Planning Commission Staff Report

February 12, 2014
Item 6.d.

- SUBJECT:** Work Session for PUD-98 and P13-2518
- APPLICANT:** Keith Henderson for CarMax Auto Superstores
- PROPERTY OWNER:** Alameda County Surplus Property Authority

- PURPOSE:** Work Session to review and receive comments on applications for PUD Development Plan and Sign Design Review to construct an automobile dealership consisting of an approximately 13,064-square-foot sales and presentation building, approximately 45,000-square-foot service building, vehicle sales display area, non-public car wash, project signage, and related site improvements on approximately 19.66 acres of the Auto Mall site at Staples Ranch.

FIGURE 5: East Elevation of FQC Building

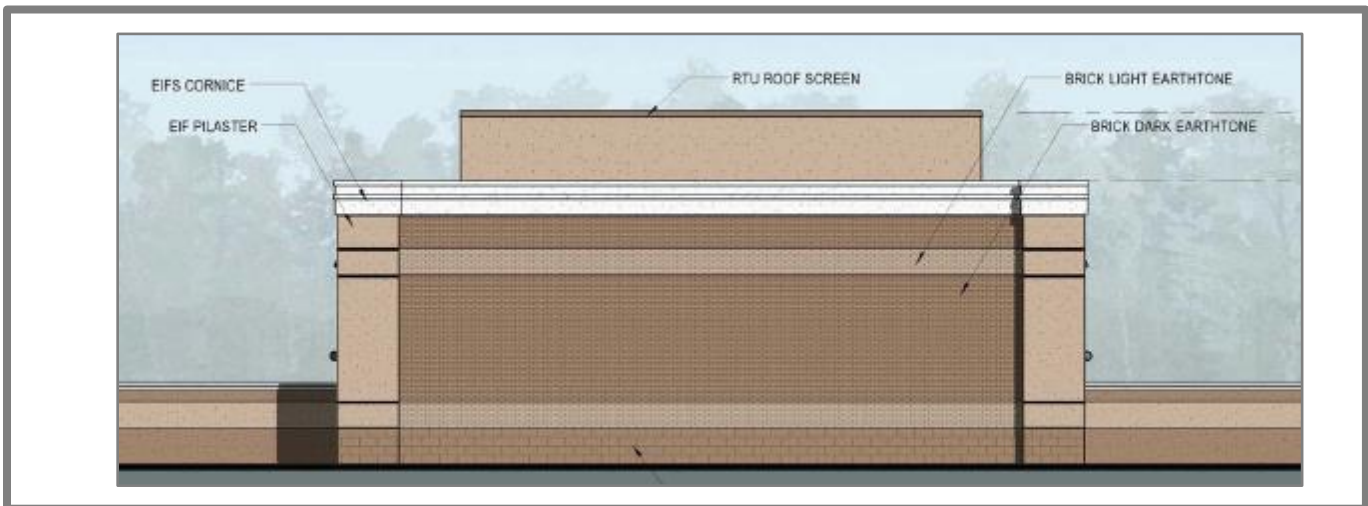
- b. Final Quality Control and Car Wash: The final quality control (FQC) and non-public car wash building is located south of the sales and presentation building and is accessible only to employees for final preparation of vehicles. A fuel pump is also proposed adjacent to the FQC building. Materials are similar to the sales and presentation building. The height of the building to the cornice is 21-foot and the height to the roof screen is 26-feet. Figure 5 shows the east elevation of the sales and presentation building. Since this façade is in a prominent location and faces the customer/employee parking lot, staff has

requested that the applicant incorporate glazing in addition to architectural details, to which the applicant has agreed.

FIGURE 6: South and East Elevations of the Service Building

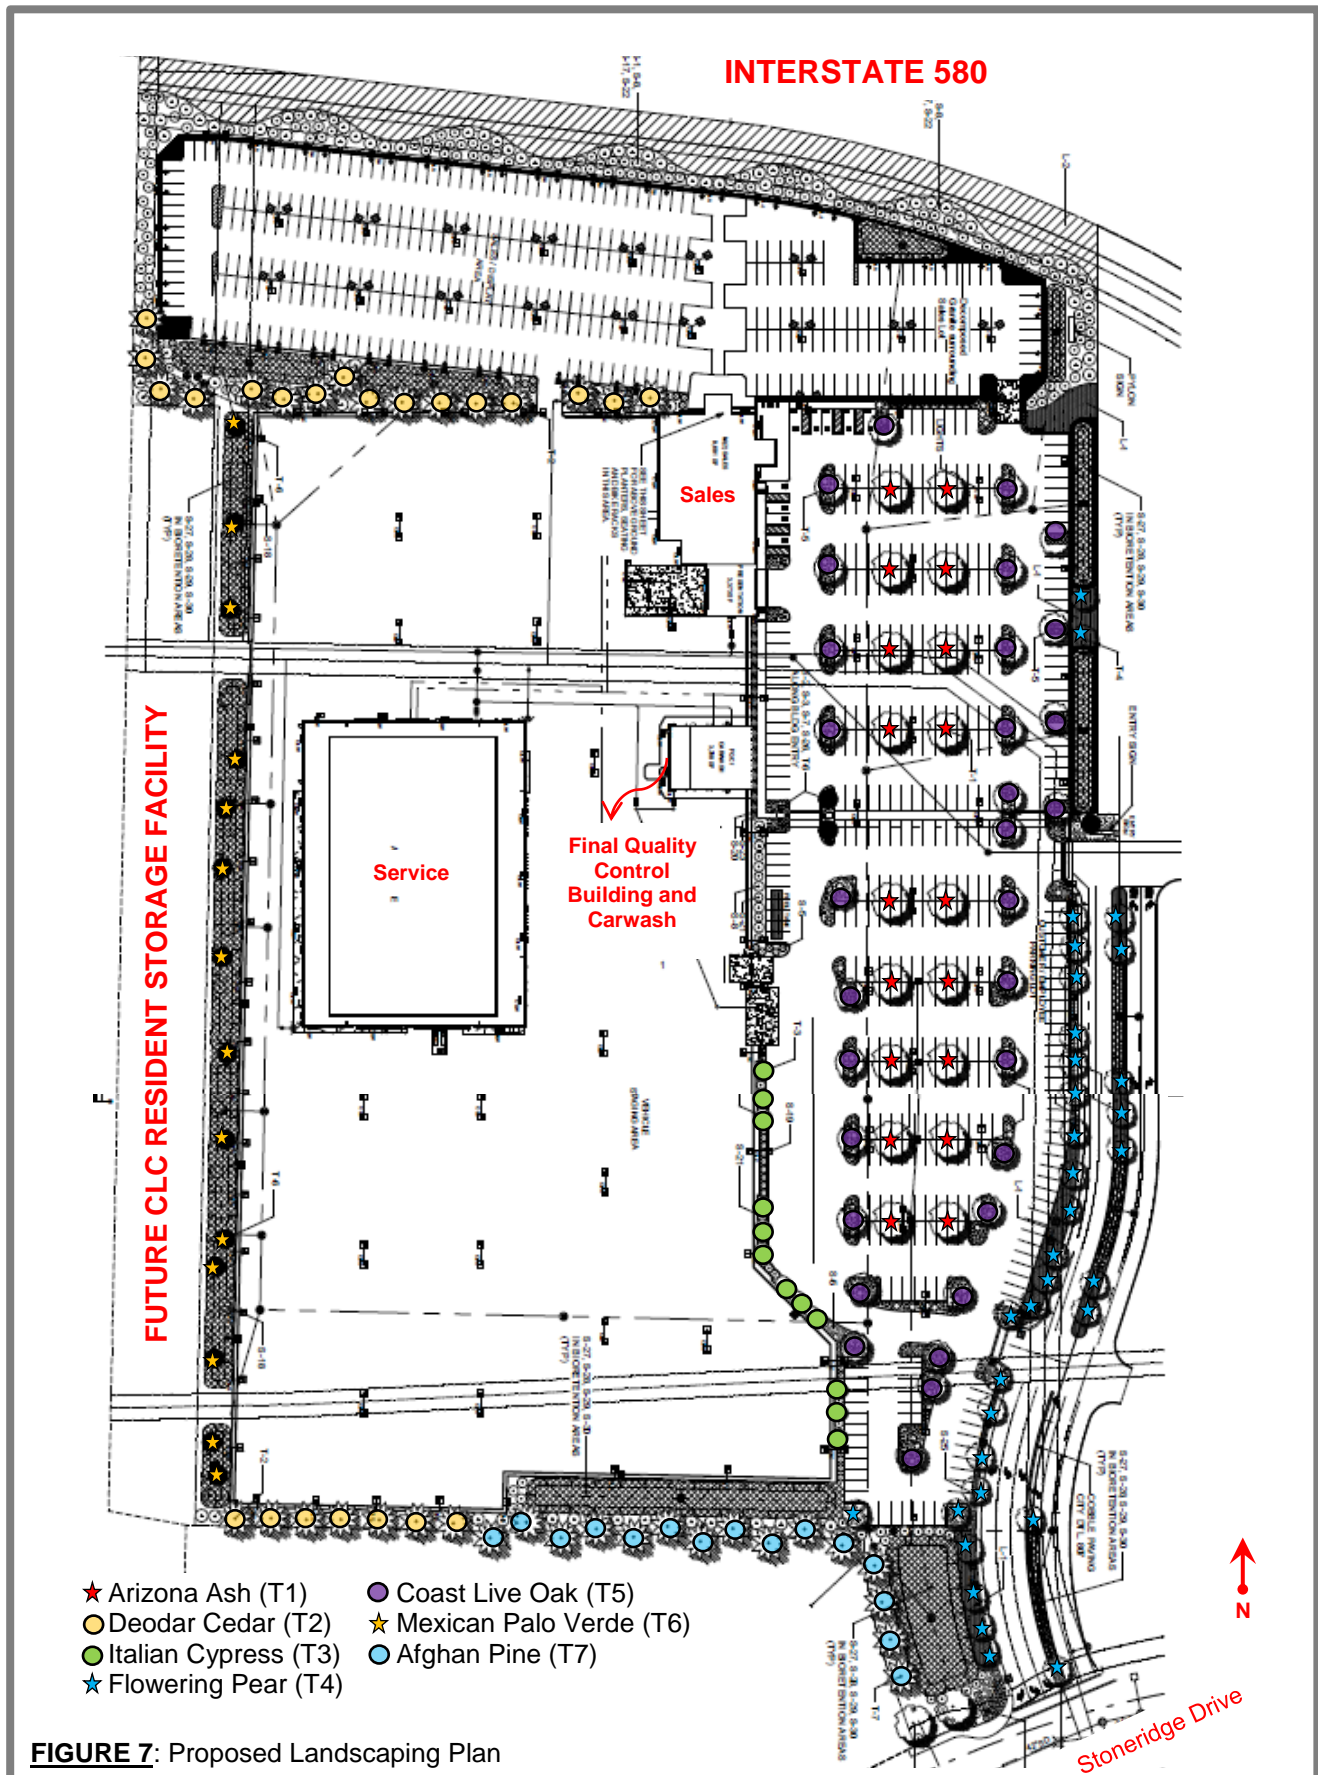
Consistent with Design Standard 1.3.5 in the Specific Plan, staff has requested that the applicant incorporate landscaping (e.g. green walls and/or trees) around the service building to soften its appearance. The applicant has indicated that landscaping in the vehicle staging area is not possible due to operational constraints and corporate standards, and further, its visibility is limited due to the fact that it is located within the vehicle staging area. In order to reduce the apparent massing of the service building, the applicant has added trellises to the east, north, and south elevations, and proposes to plant 24-inch box-size cedar trees outside the vehicle staging area to screen the building.

Providing trees and landscaping immediately around the service building would provide screening closer to the building, allowing for better screening, and create shadows on the building from the trees. Given the proposed design and size of the service building, staff's objective is to screen it adequately from the Neighborhood Park, Stoneridge Drive, Interstate-580, and the adjacent CLC site.

C. Are the proposed architecture, architectural detail, and landscape screening for the service building acceptable?

FIGURE 10: Proposed Pylon Sign and Building-Mounted Sign

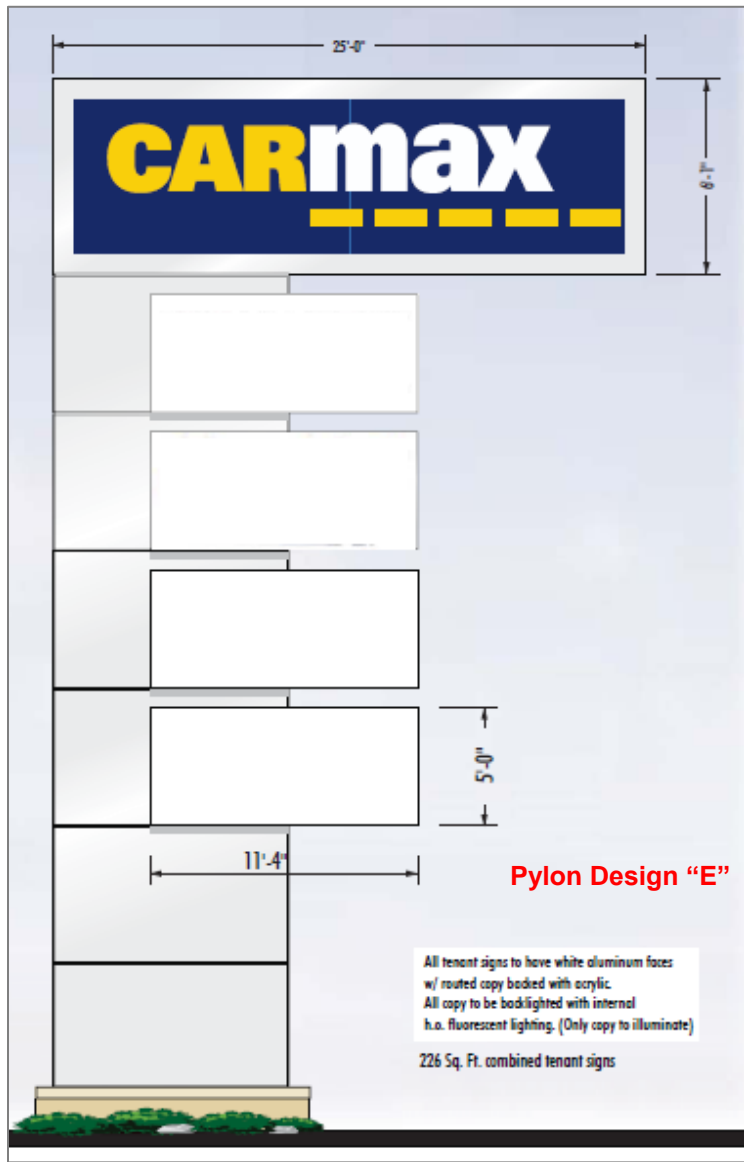
As mentioned in this report, a pylon sign is proposed along Interstate-580 and a monument sign is proposed facing Stoneridge Drive. The plan sheets for this workshop include several different options for the pylon sign, which are all proposed to be 45-feet tall (this is within the 48-feet maximum permitted by the Specific Plan). Since the remainder of the auto mall site will be developed in the future, and the Specific Plan limits freeway

same color for the background panels would allow for a more visually consistent sign (instead of only one panel being blue and others white, or multi-colored panels). Further, staff would like the applicant to provide a nighttime view of the sign.

Figure 11 in this staff report and Sheet 4 of the sign plan indicate a sign at the drive entrance to the site from Stoneridge Drive. Instead of a multi-tenant sign at this location, staff finds the proposed single-tenant sign to be more appropriate for the location since the other side of the entry drive provides a location for the future auto developer's signage, and also provides the applicant the ability to reduce the sign height from 8-feet to 6-feet (this modification would be shown on future plans).
